# CITY OF ALBUQUERQUE

RE: **Lot 7 Block 10, Volcano Cliffs, Unit 22, SAD 228  
6408 Petirrojo NW  
Grading and Drainage Plan  
Engineers Stamp Date 2/15/19 (D10D003F7)**

Based upon the information provided in your submittal received 2/14/19, this plan is approved for Grading Permit.

<div>ENGINEER'S SEAL</div> <div></div> <div>DAVID SOULE P.E. #14522</div>	6408 PETTIRROJO	DRAWN BY WCVJ
	GRADING AND DRAINAGE PLAN	DATE 2-13-19
	<div>Rio Grande Engineering 1606 CENTRAL AVENUE SE SUITE 201 ALBUQUERQUE, NM 87106 (505) 872-0999</div>	219008-LAYOUT-2-13-19
		SHEET #
		JOB # 219008

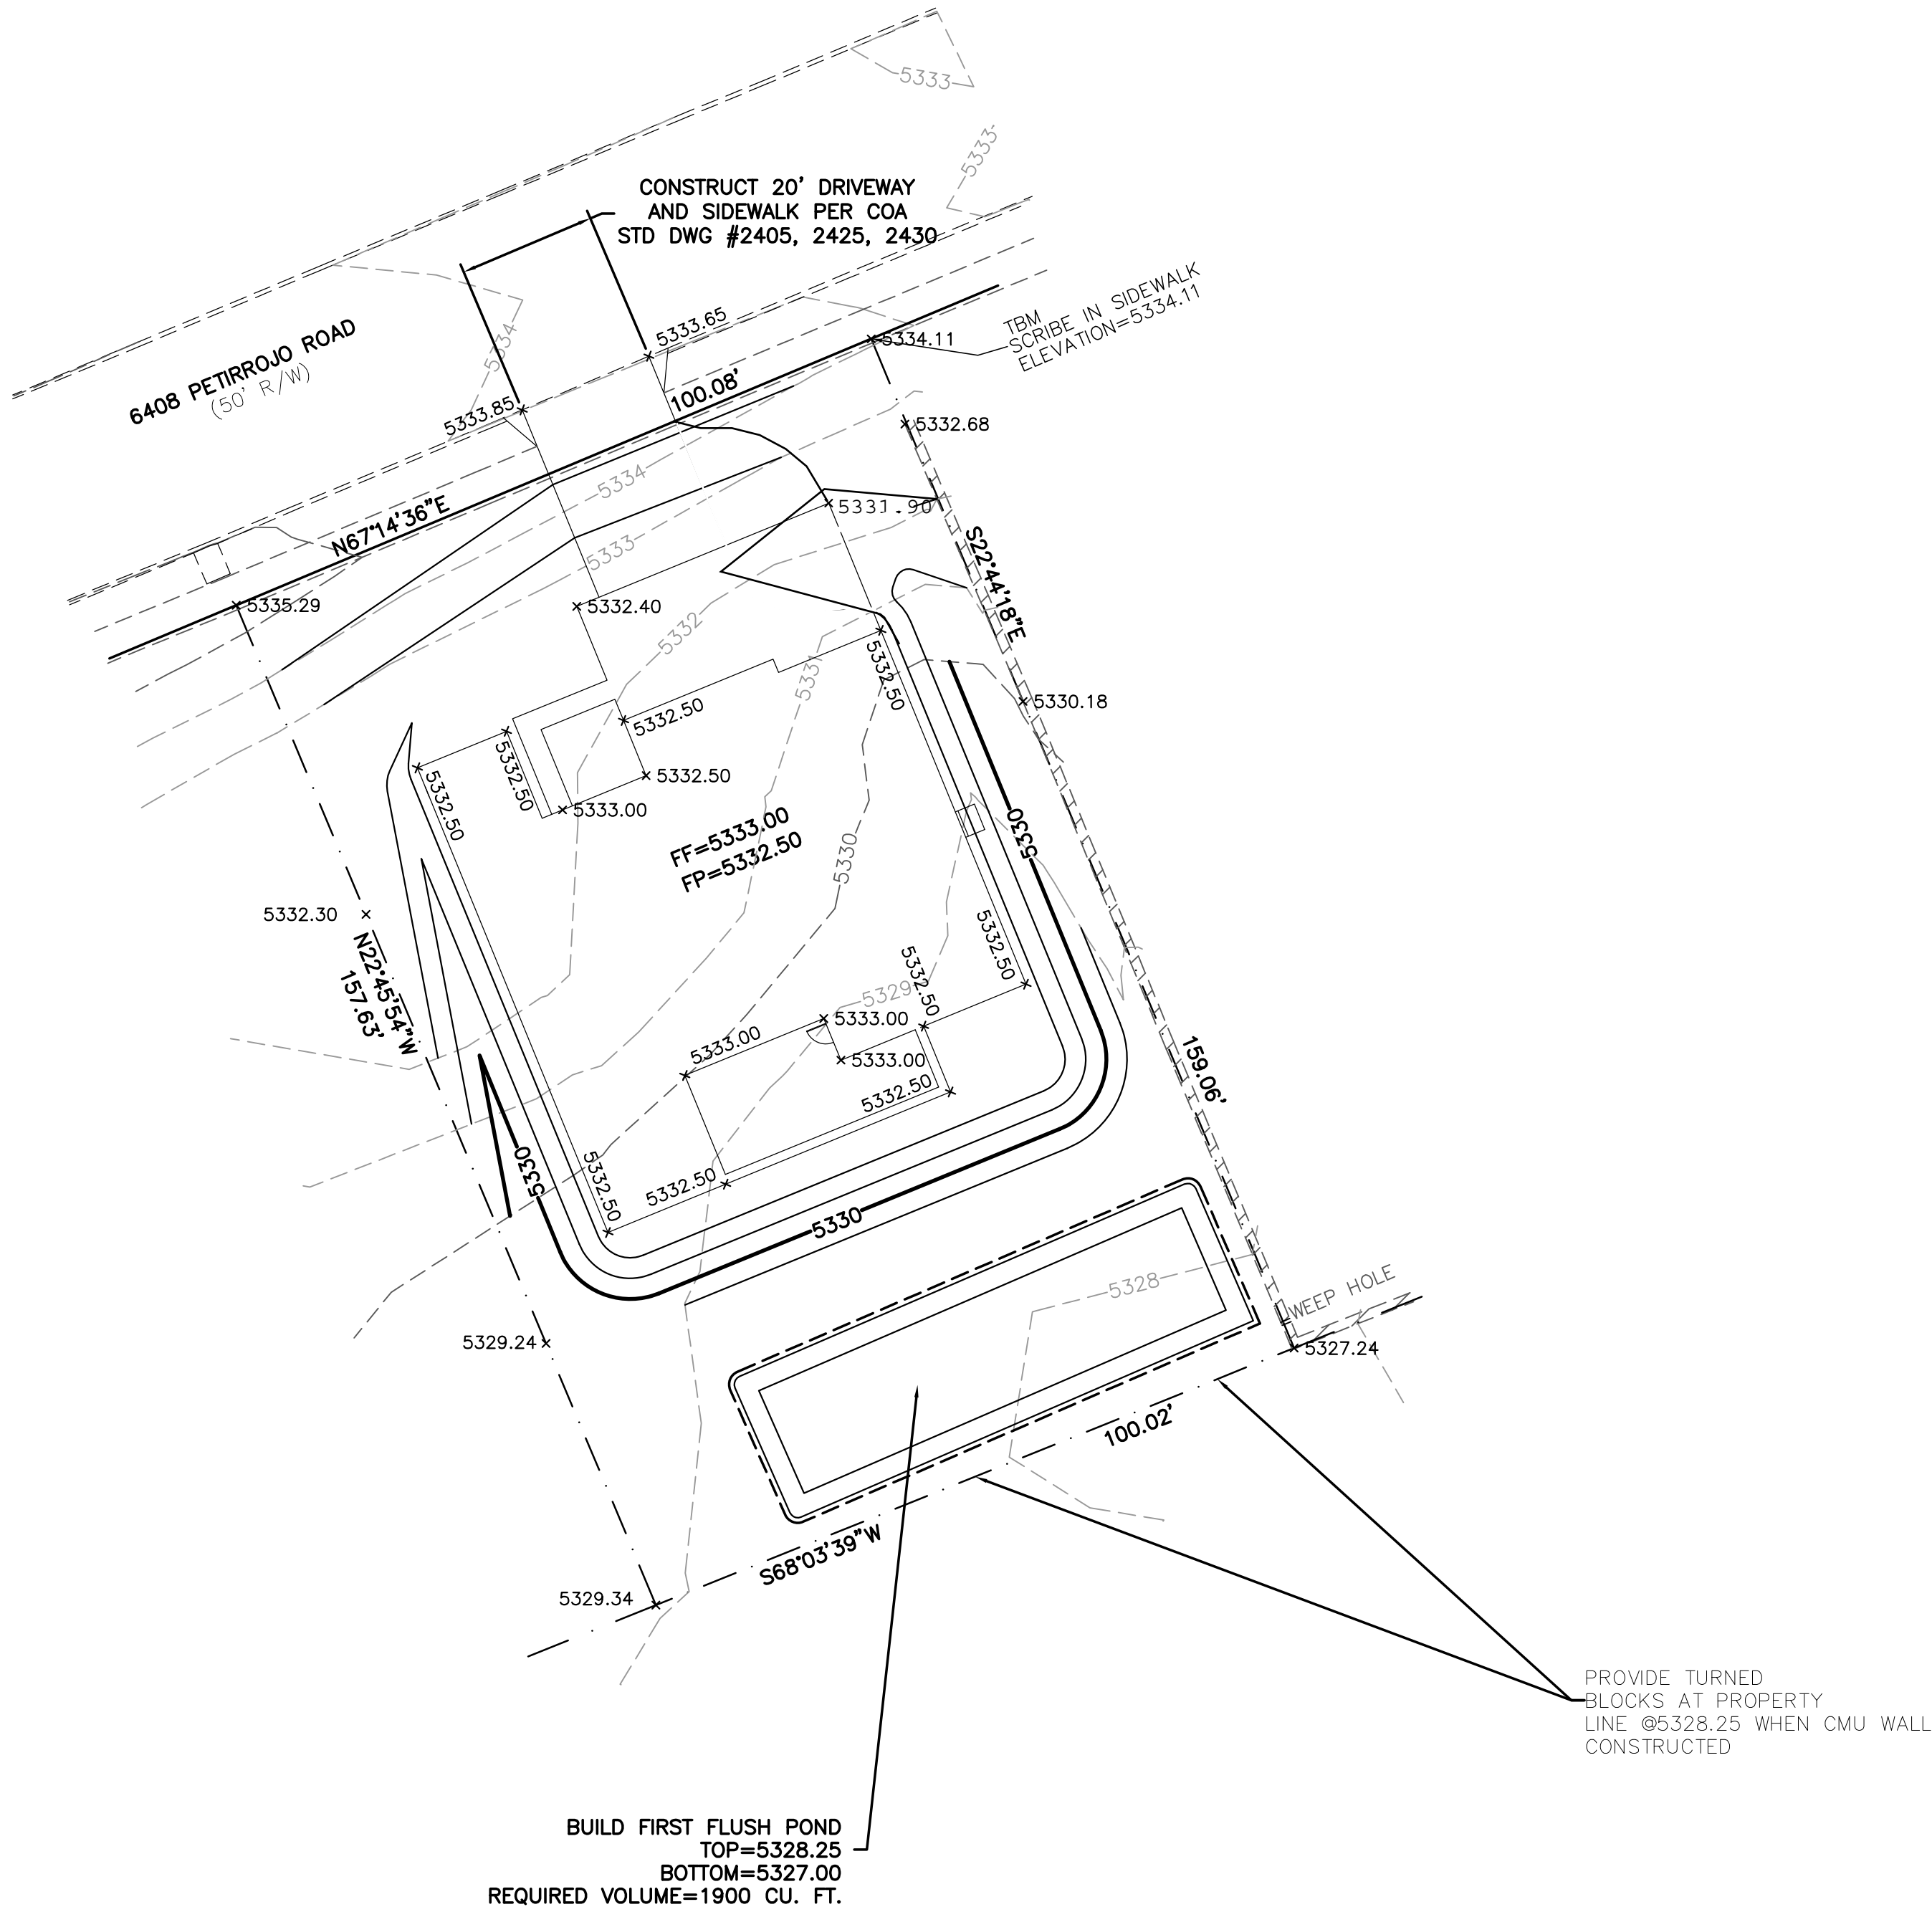
**Prior to Building permit approval a Pad Certification will be required, provided by the Engineer or a registered Land Surveyor.**

Reiterate to the Owner/Contractor that a separate permit for a garden/retaining wall must be obtained with the approved G&D plan and Pad Certification.

**Prior to Certificate of Occupancy release, Engineer Certification per the DPM checklist is required.**
